Project	IEEE 802.16 Broadband Wireless Access Working Group < <a href="http://ieee802.org/16">http://ieee802.org/16</a> >	
Title	Modified Pilot Allocation for AMC and Optional PUSC Uplink Subchannels for STC Mode	
Date Submitted	2004-06-25	
Source(s)	Erik Lindskog, K.Giridhar, Aditya Agrawal, David Garrett, Taiwen Tang, Harold Artes, Kamlesh Rath, Tareq Al-Naffouri, B. Sundar Rajan, Djordje Tajkovic, Sriram Modulodu, Ying Xia, Richard Compton, A. Paulraj, Babu Mandava, and Robert Lorenz Beceem Communications, Inc. Freedom Circle, Suite 101 Santa Clara, CA 95054	Voice: +1-408-387-5014 Fax: +1-408-387-5010 <a href="mailto:elindskog@beceem.com">elindskog@beceem.com</a>
Re:	802.16e/D3-2004	
Abstract	We propose a modification of the pilot allocation scheme in the AMC and Optional PUSC subchannels to support up to two antennas on the uplink. This pilot allocation enhances the channel estimation performance for highly frequency selective channels, without affecting the existing subcarrier permutations.

## Modified Pilot Allocation for Uplink STC using AMC Modes

*Figure 1(b) : Modified pilot allocation for 1x6 Band AMC tile for single antenna uplink*

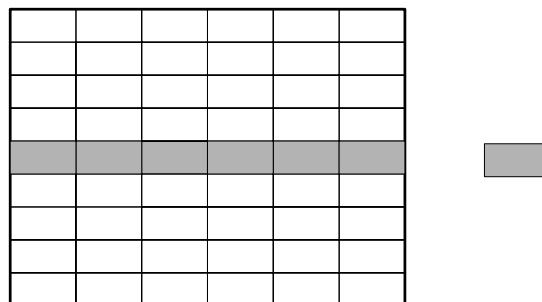
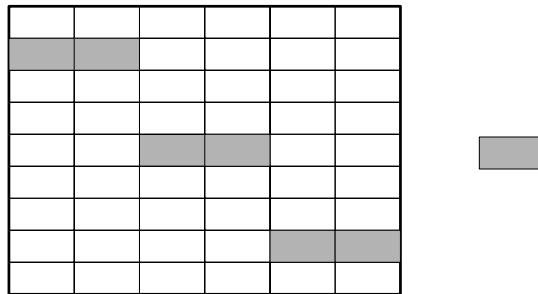
We propose to replace the existing 1x6 tiled band AMC sub-channel

with a new 1x6 sub-channel pilot mapping which can estimate the frequency response over the entire bin in a better manner. This is achieved by allowing the pilots to sweep across the frequency band, over the 6 symbol times, as shown below:

The allocation above also enables temporal smoothing of the frequency response over adjacent OFDMA symbols, thereby preserving the robustness of the pilot based tracking loop to Doppler induced temporal fading. In the case of STC where the SS employs two transmit antennas, the pilot allocations for antenna-0 and antenna-1 for the 1x6 tile defined by band AMC are as follows:

*Figure 2(a) : Existing and Proposed pilot allocation for 2x3 Band AMC tile for single antenna uplink.*

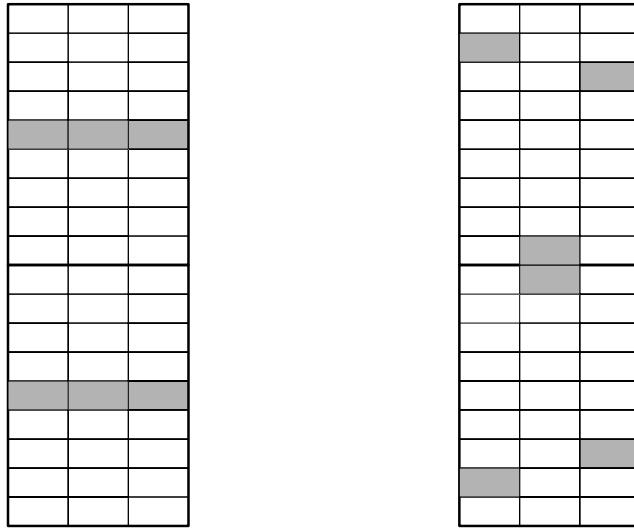
We propose to replace the existing 2x3 band AMC subchannel giving on the left, with the proposed new pilot allocation shown on the right, for the single antenna uplink

*Figure 2(b) : Modified pilot allocations for antenna-0 and antenna-1 for 2x3 band AMC. No symbol or carrier is transmitted on subcarriers marked with an X.*

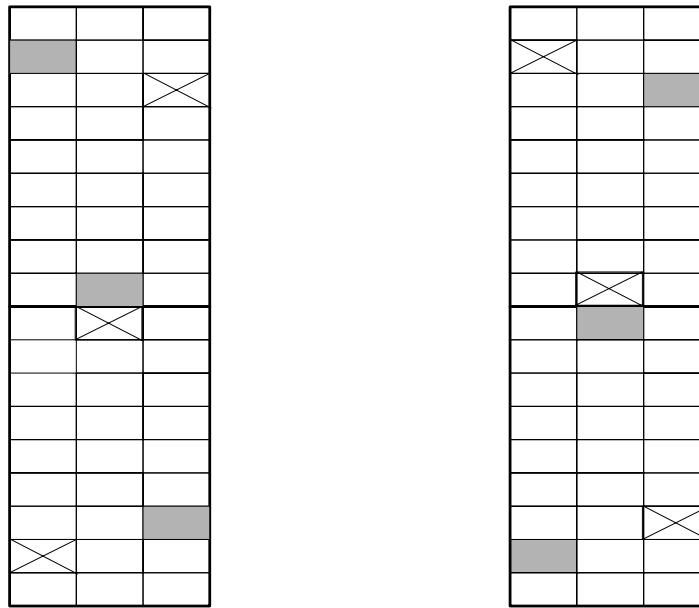
For two transmit antennas, the modified pilot allocation for the uplink 2x3 band AMC mode is as follows:

*Figure 3(a) : Existing pilot allocation on the left, and the proposed pilot allocation on the right, for the 3x2 uplink*

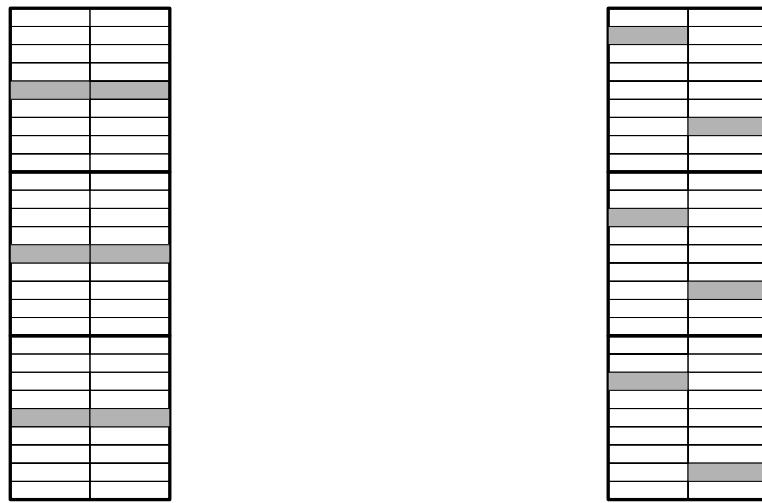
We propose to replace the existing 3x2 band AMC sub-channel shown on the left, by the allocation shown on the right, in the figure below.

*Figure 3(b) : Proposed pilot allocation for 3x2 Band AMC. No symbol or pilot is transmitted on subcarriers marked with an X.*

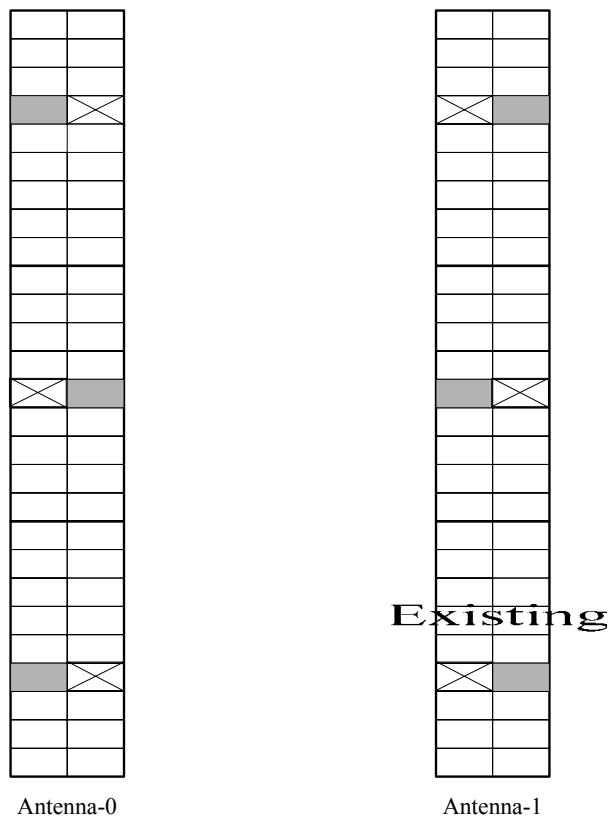
For two transmit antennas, the modified pilot allocation for the uplink 3x2 band AMC subchannel is as shown below for both the antennas.
